City of Linden
Union County, New Jersey
Department of Community Services
Division of Engineering

May 7, 2020

Re: *Application No. SP 1111-19*
Zone: LI and RPZ Overlay
Nicholas Patti Holdings LLC.
Site Plan Approval
Block 568 Lot Nos. 2, 3, & 4
37 West 21st Street, Linden, NJ

CURB AND SIDEWALK JOINTS

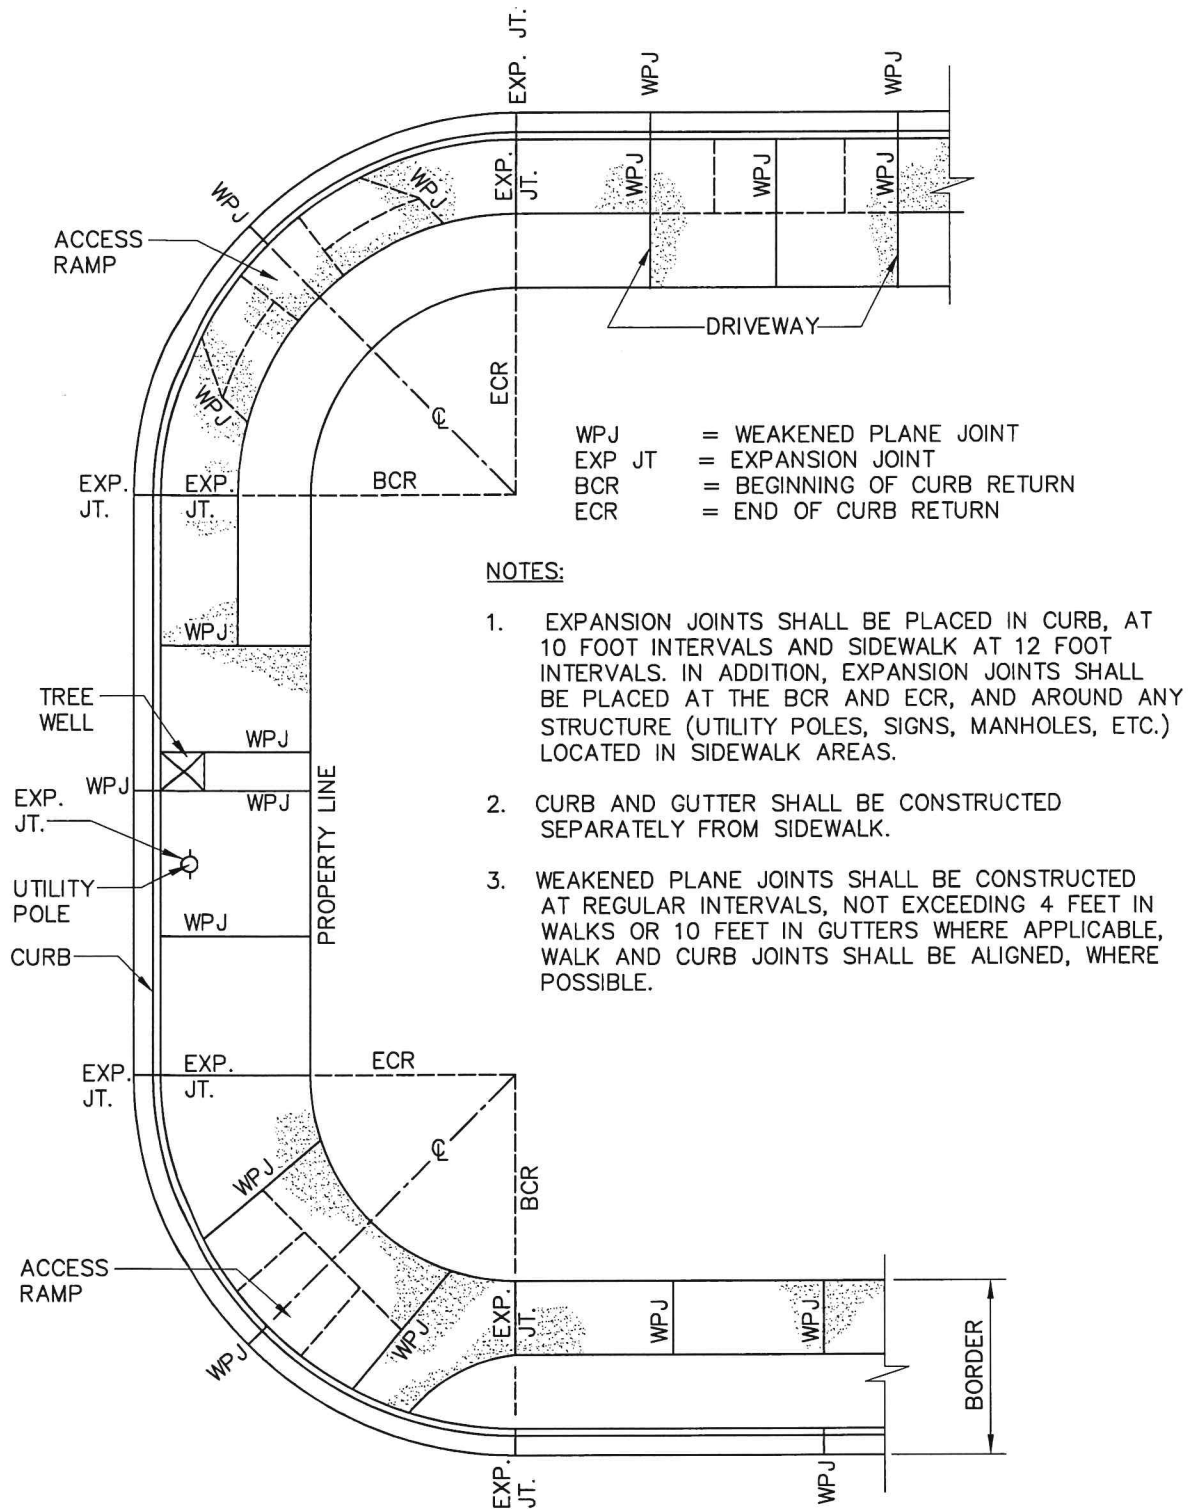
Applicant's Engineer to make appropriate revisions to entire drawing set;
 - The concrete curb detail shall be as per the City's standard. Transverse joints ½" wide shall be placed 10 ft. apart in the curb. Copy attached for your reference;
 - The following construction details shall be added to the plans:
 - Typical Roadway Excavation & Restoration at Curbs;
 - Depressed Curb at Driveways;
 - Concrete Driveway Apron, Typical Section;
 - Hot Mix Asphalt Pavement Trench Restoration;
 - Curb and Sidewalk Joints.
- **Sheet S1 of Set** – This sheet is incomplete and needs to be revised to show dimensions of all four sides of the proposed building, including any openings and façade types. Such attributes are typically represented on an Architectural Drawings, signed & sealed by a Licensed Architect?
